ADDENDUM NO. 1**NEBRASKA AVENUE WATER MAIN REHABILITATION
COUNCIL BLUFFS WATER WORKS
July 31, 2026**

Project: **NEBRASKA AVENUE WATER MAIN REHABILITATION**
Council Bluffs Water Works
Snyder & Associates, Inc. Project No. 125.1319.01

CONSTRUCTION PLANS FOR
NEBRASKA AVENUE WATER MAIN REHABILITATION
COUNCIL BLUFFS WATER WORKS
COUNCIL BLUFFS, IOWA

1 FULL DEPTH COMPOSITE PATCH
B.2 NO SCALE

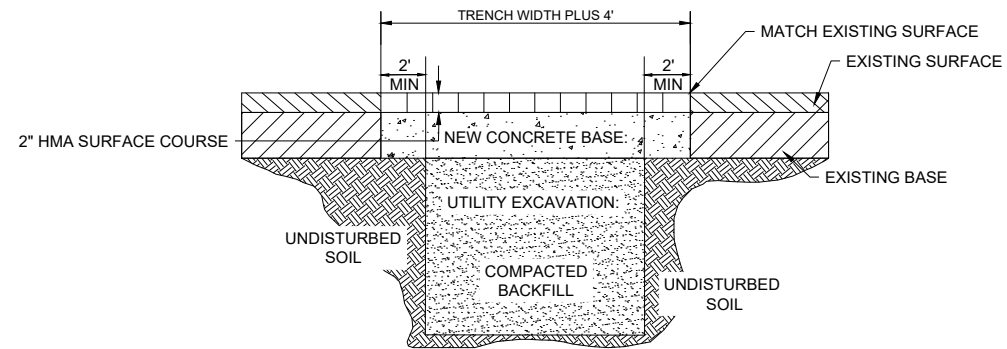
16. Please confirm that subgrade prep/treatment will not be needed in the access pit restoration. Assumed underlying soils are sand. Without Geotech information, contractors will not be able to responsively know what is needed for this work other than to assume the worst. – **detail added to plans with addendum.**

Sheet D.1

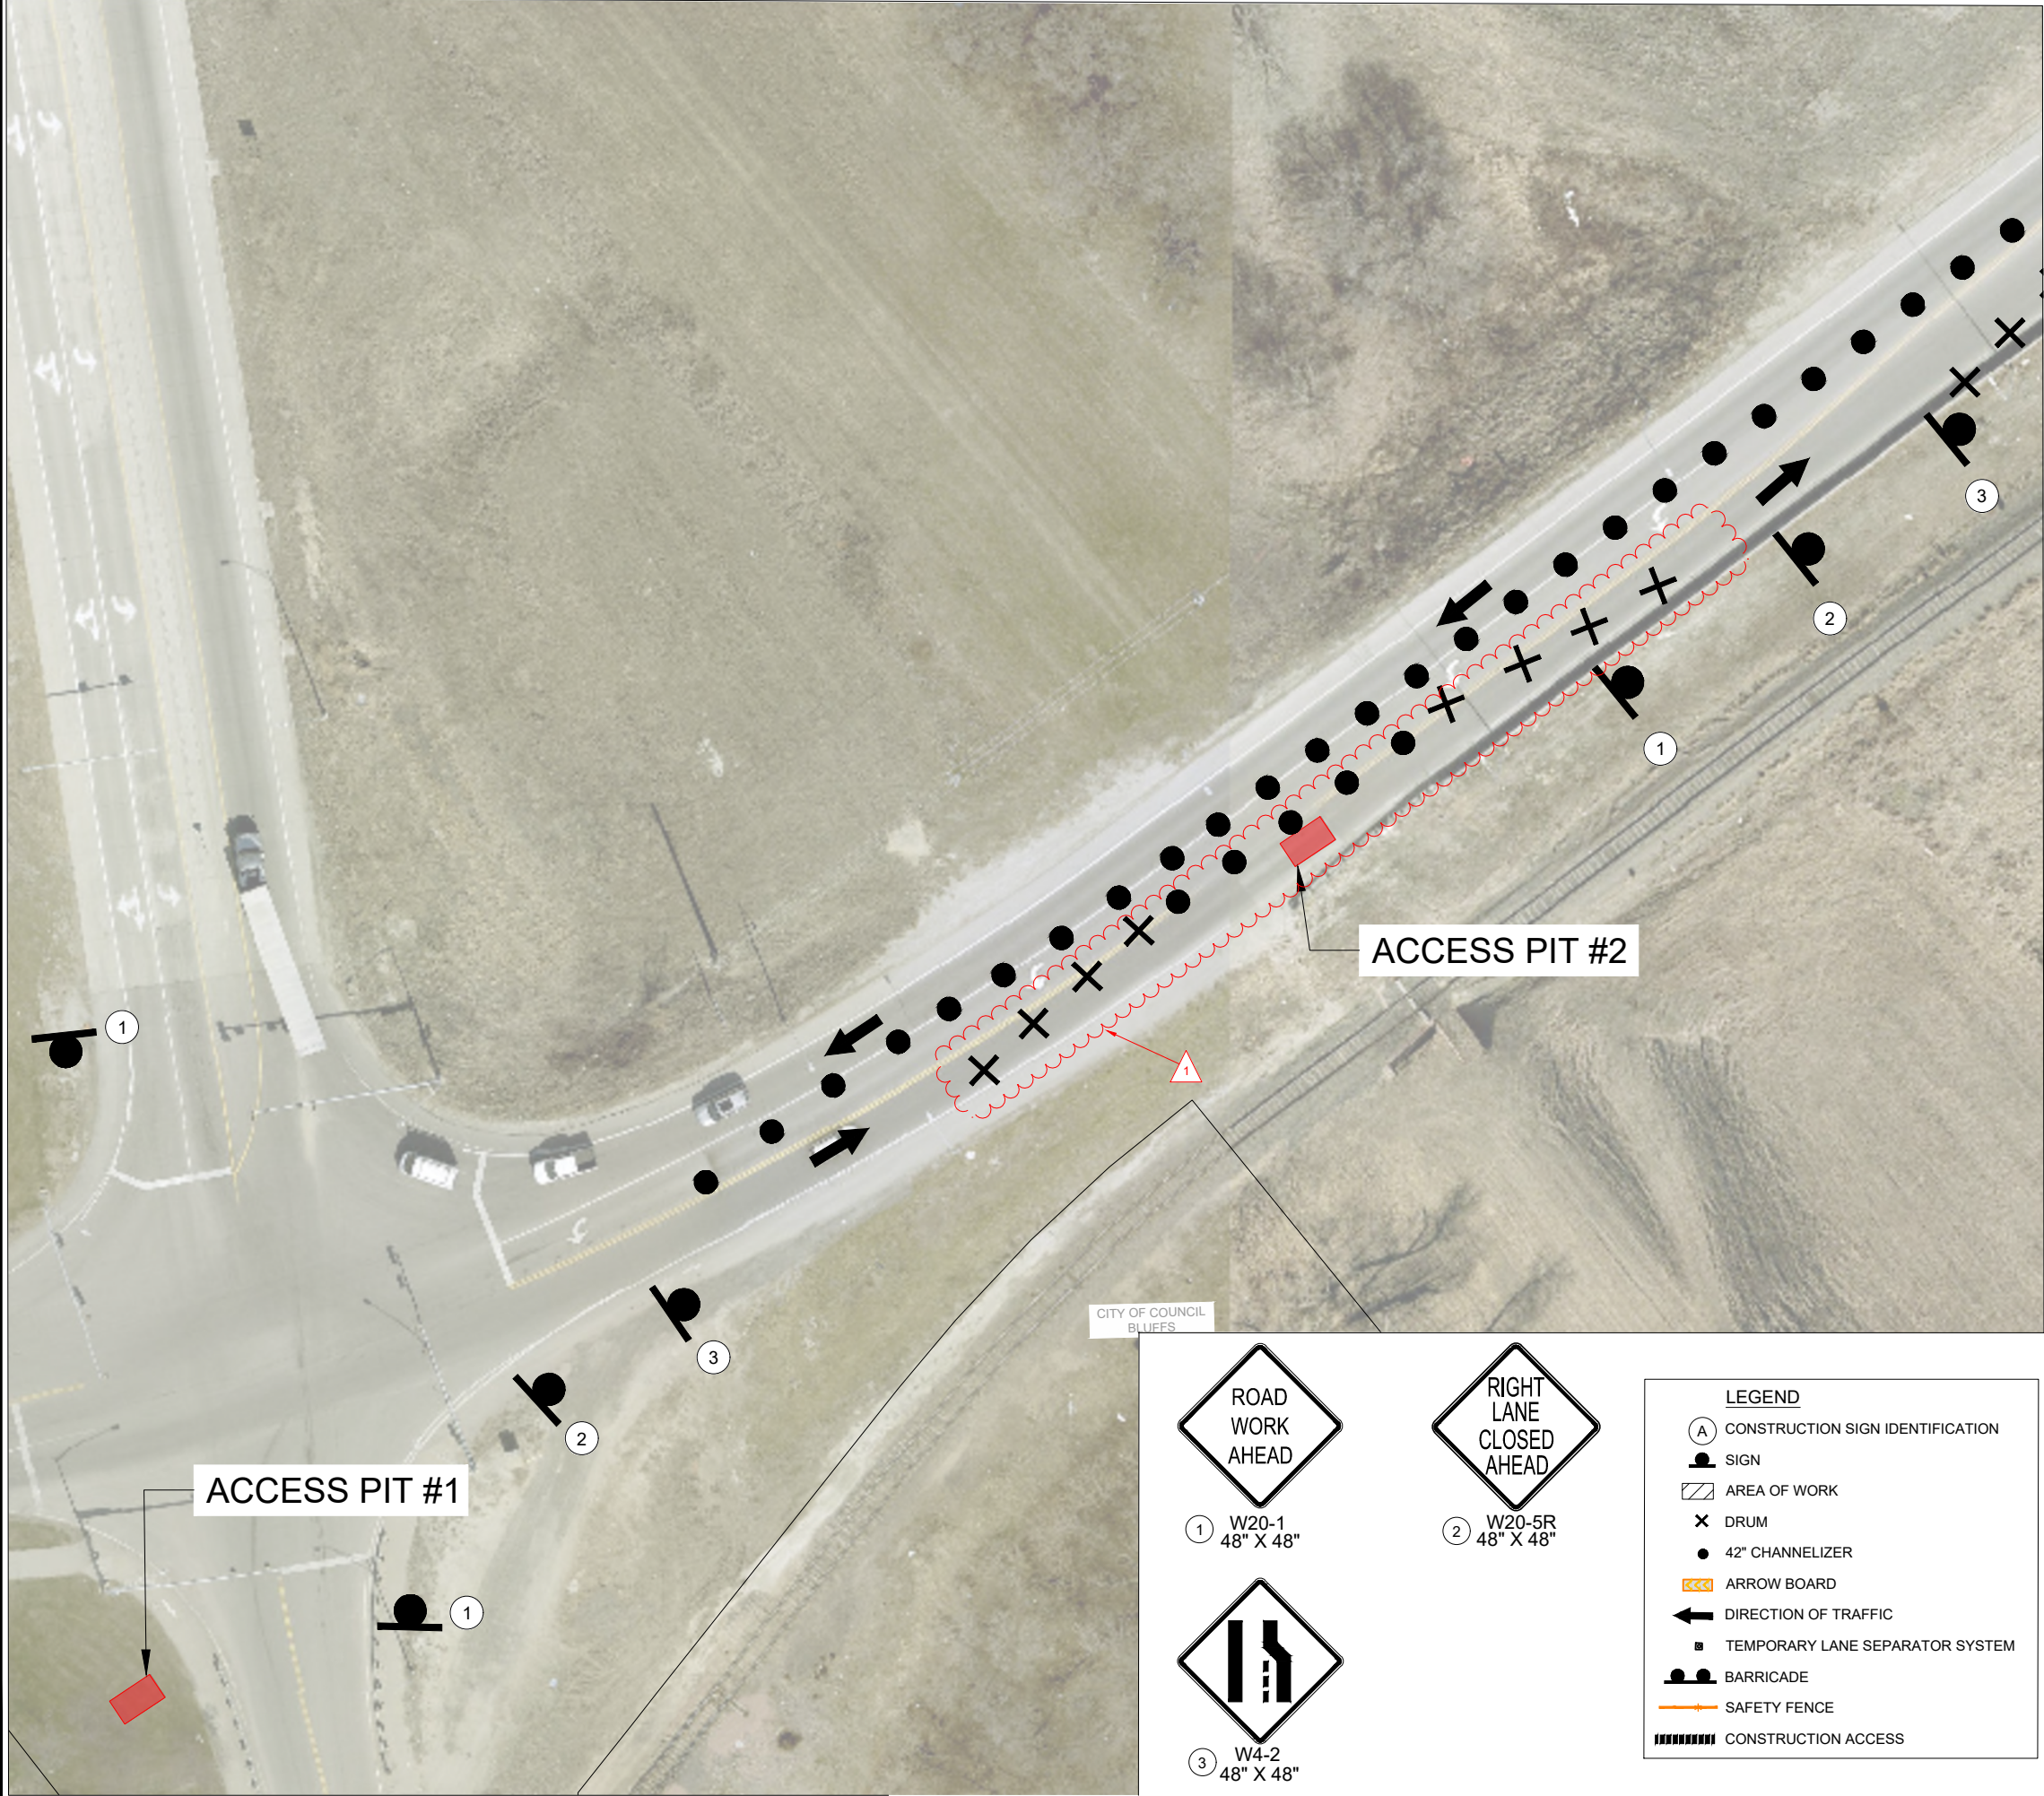
10. Sheet D.1 – Detail 1/D.1 – The 8” line heading north out of the access pit #1 does not appear to have a gate valve beyond the tee. How will this line be isolated during the execution of the Work? – **Valve near street light at intersection. This is a service line. Casino is end user.**
